RE: Event Center
1611 Airtech Ct. SE
Grading and Drainage Plans
Engineer's Stamp Date: 06/20/2024
Hydrology File: N15D017

Based upon the information provided in your submittal received 06/21/2024, the Grading & Drainage Plan is approved for Grading Permit. The following conditions need to be addressed prior to approval of Building Permit.

C-1

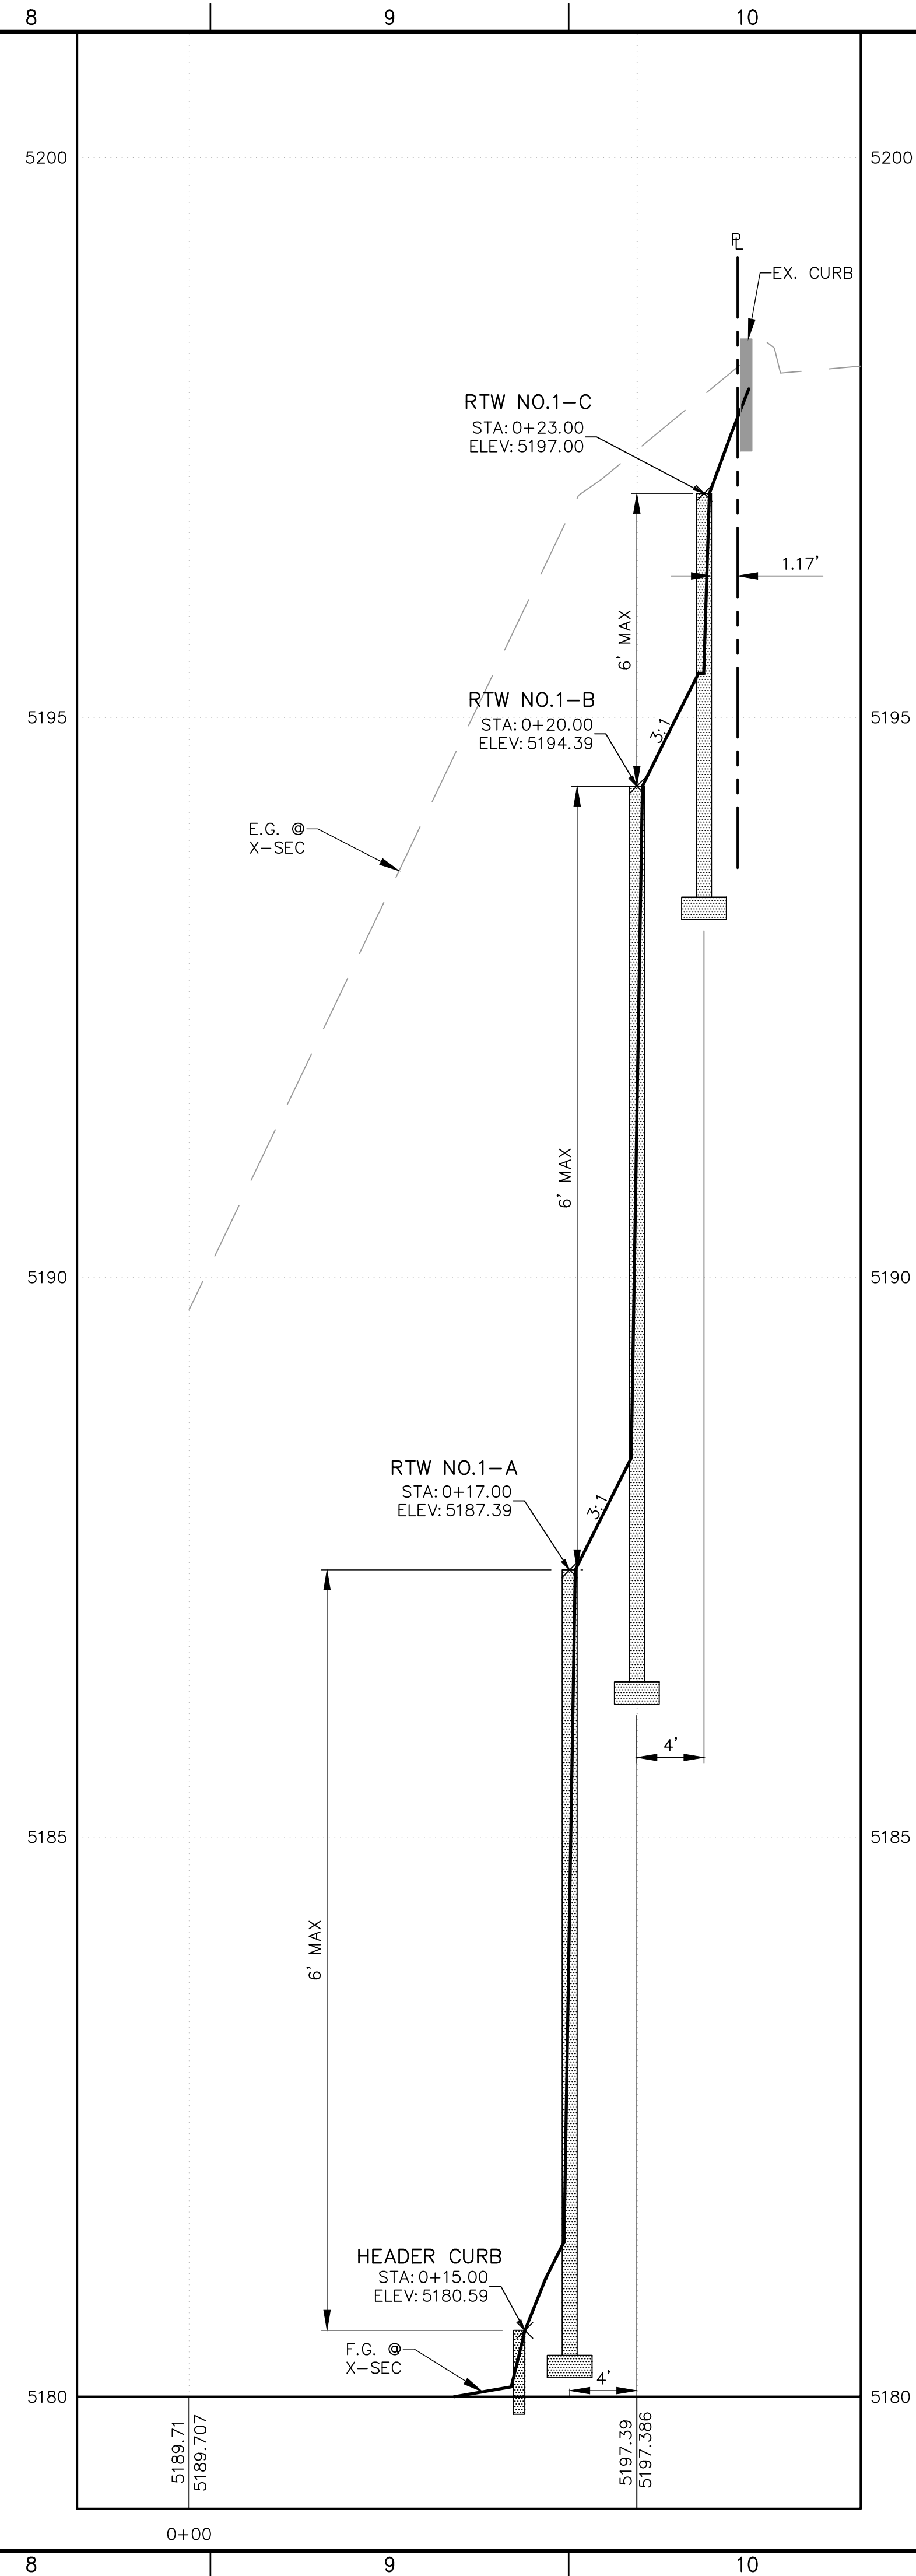
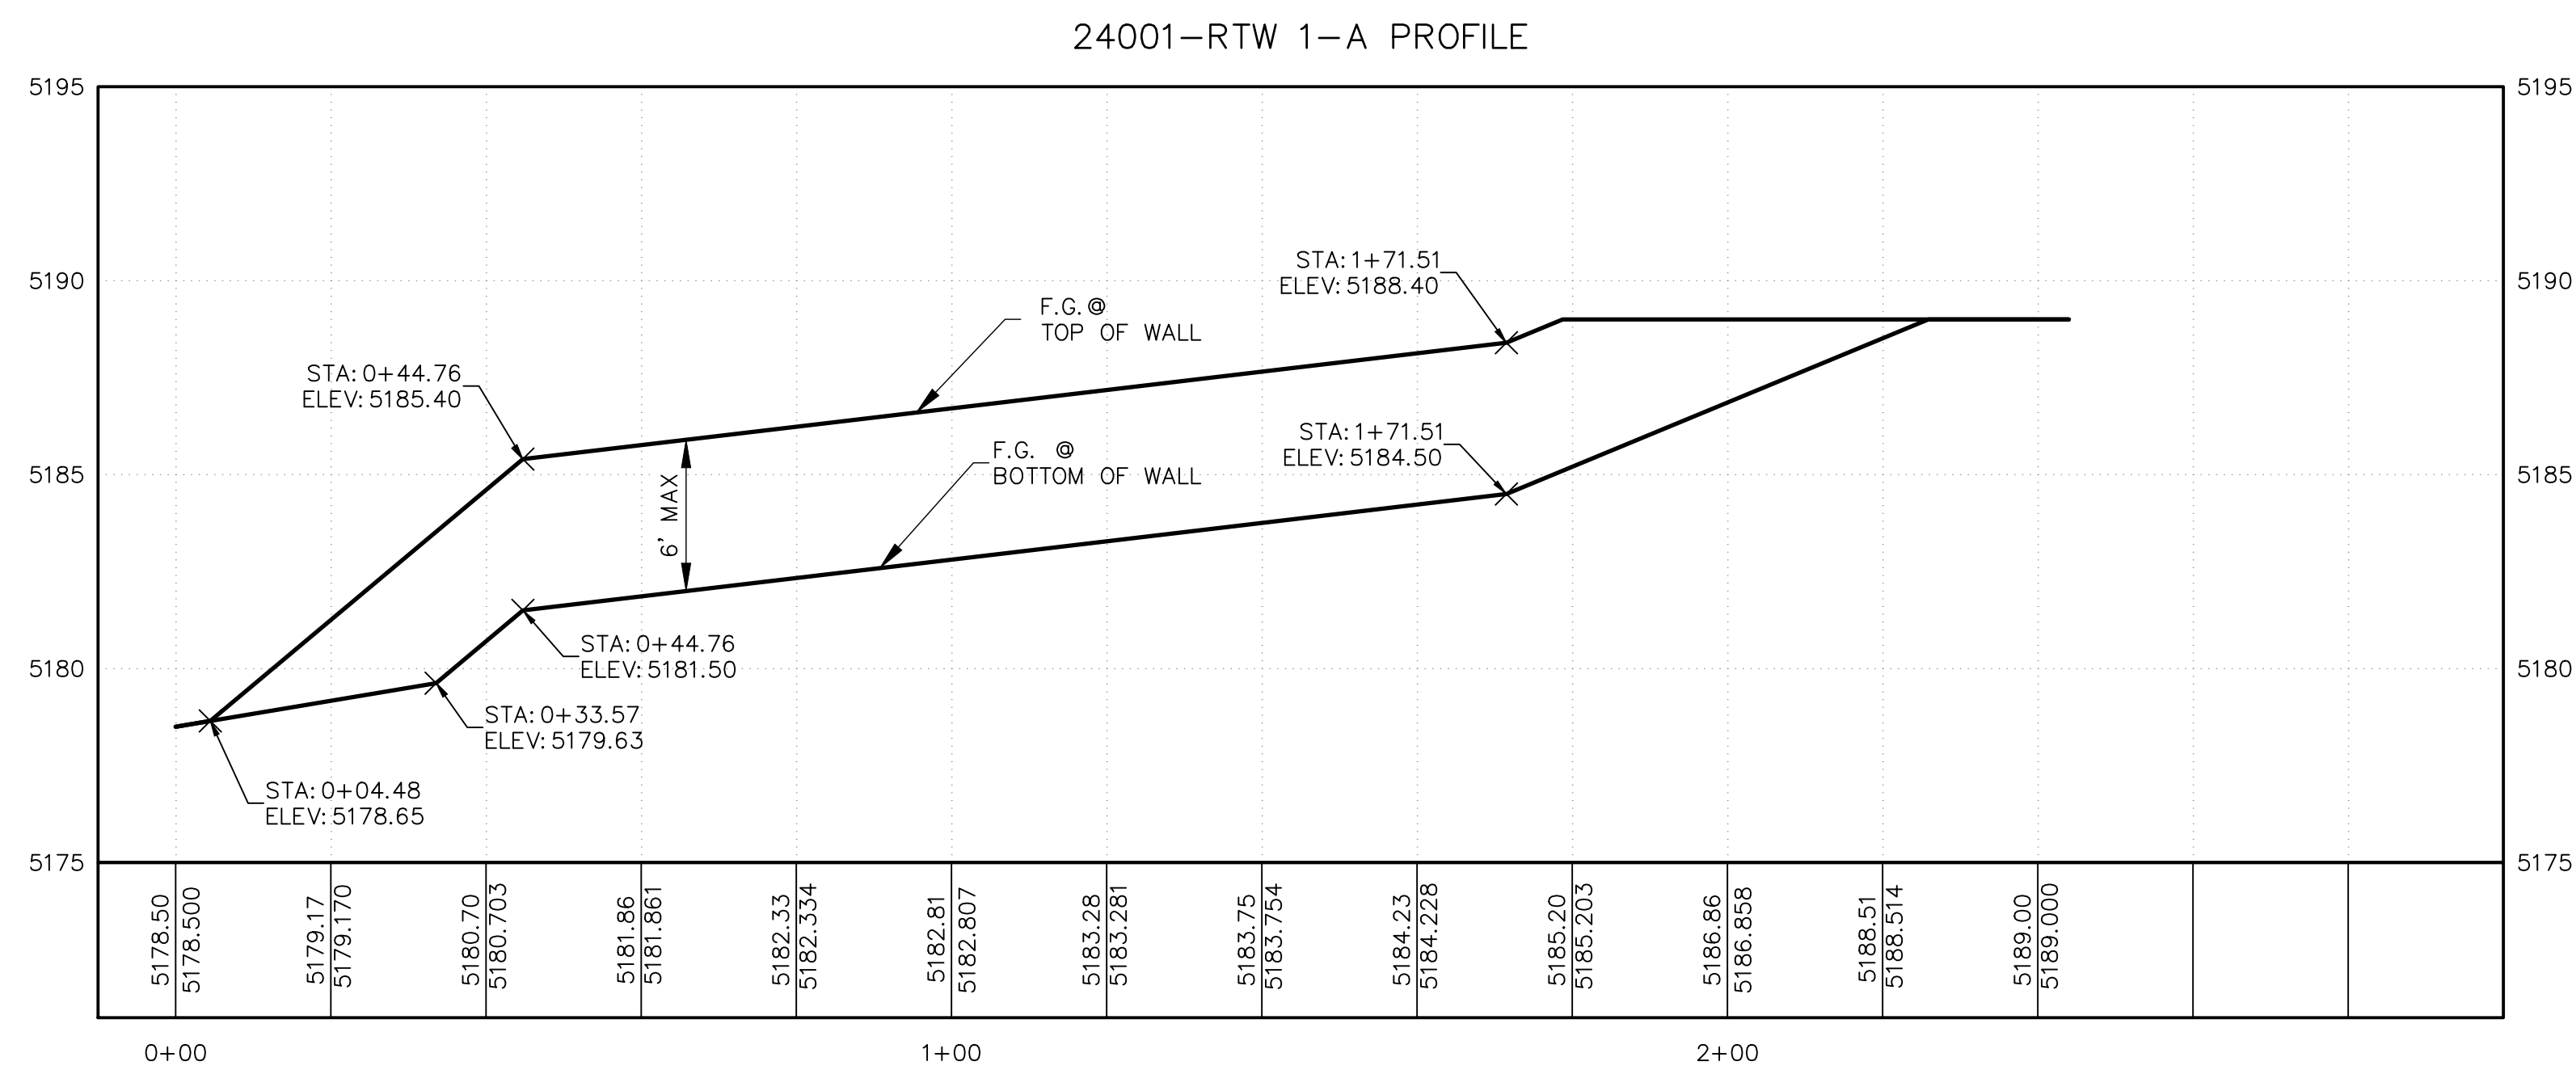
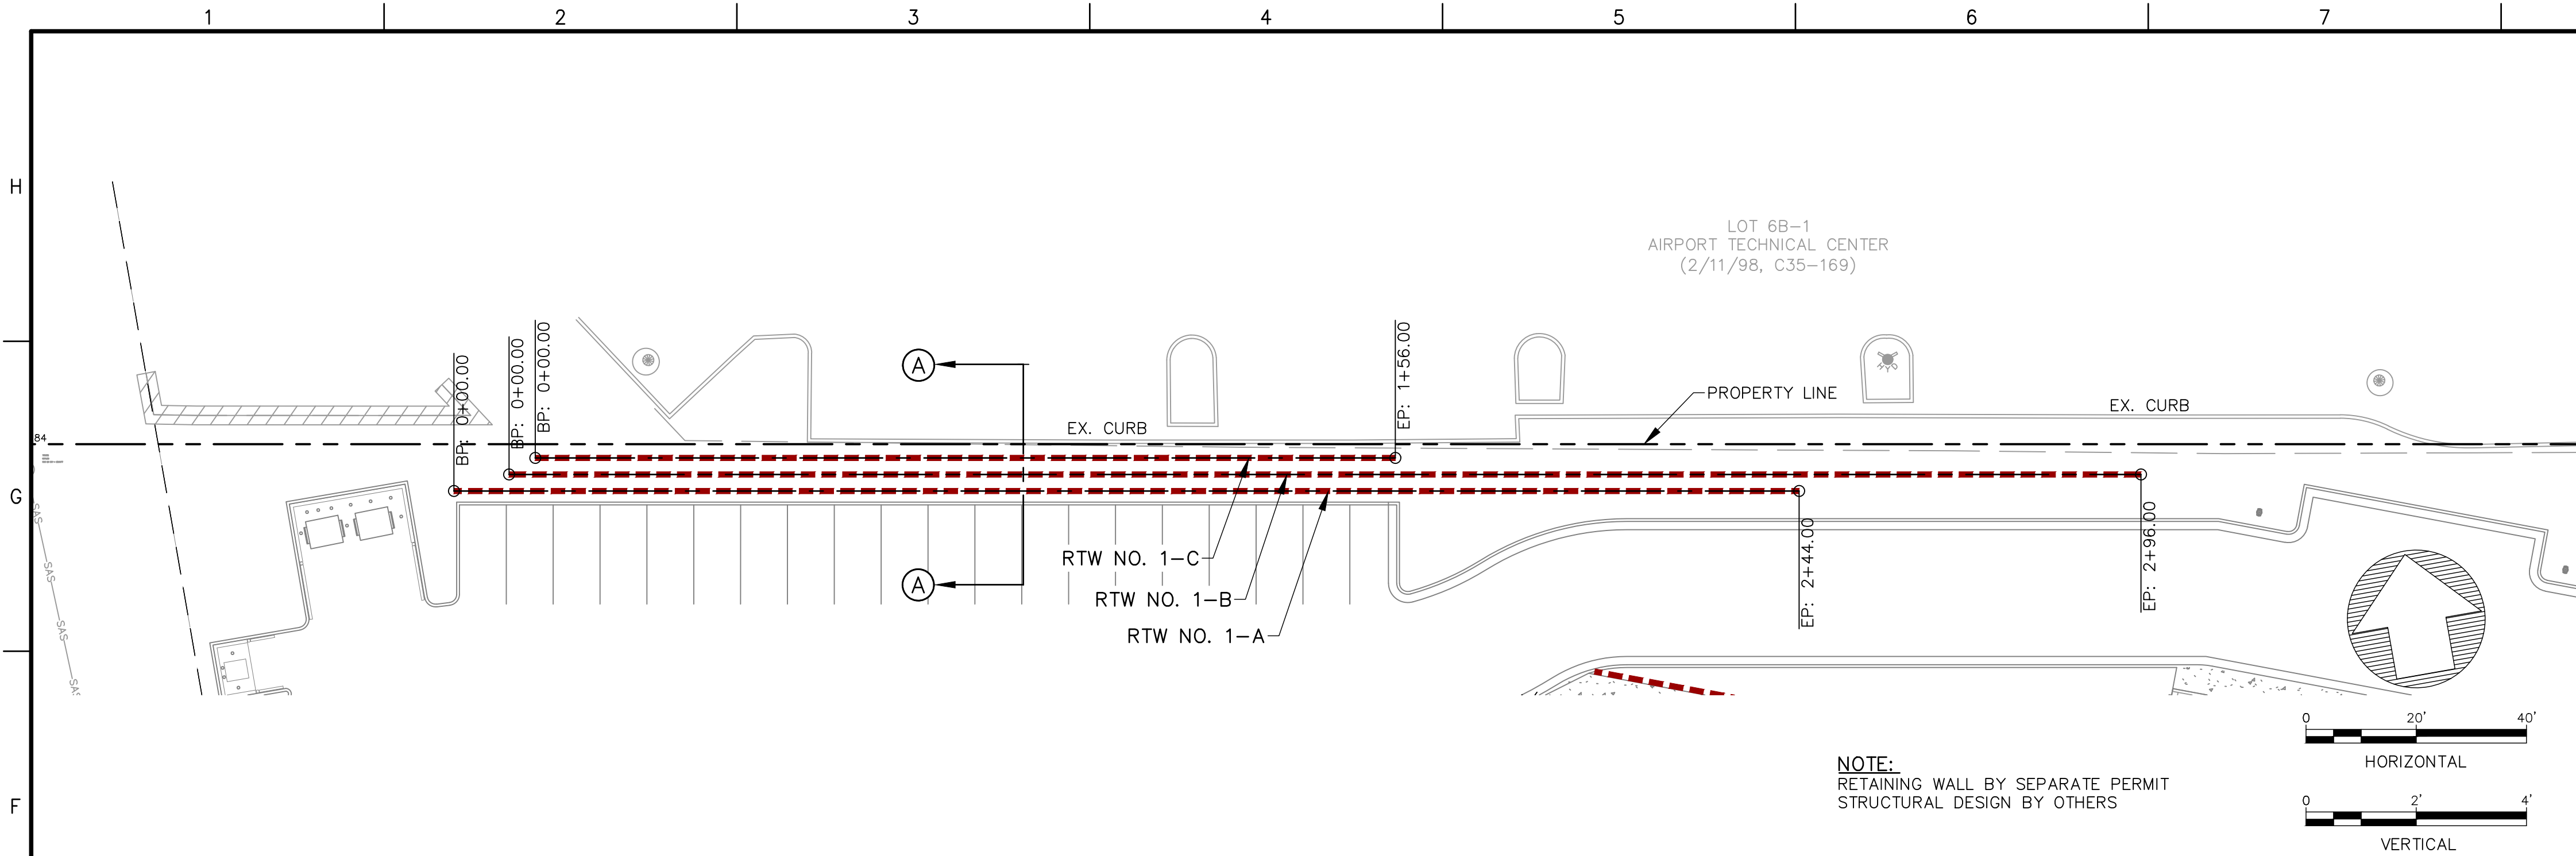
1. Rough grading must stay away 30 ft from the property lines until a firm design and assurance from a structural engineer stating that the retaining walls as designed will be buildable and will not create safety issues with the adjacent property.
2. Please provide garden wall design details. Total wall height (garden wall on top of the retaining wall) must be reviewed and approved by the Code Enforcement division.
3. Install a manhole at the location that the Type D inlet with the 18-in storm drain connecting to the existing 60-in pipe.
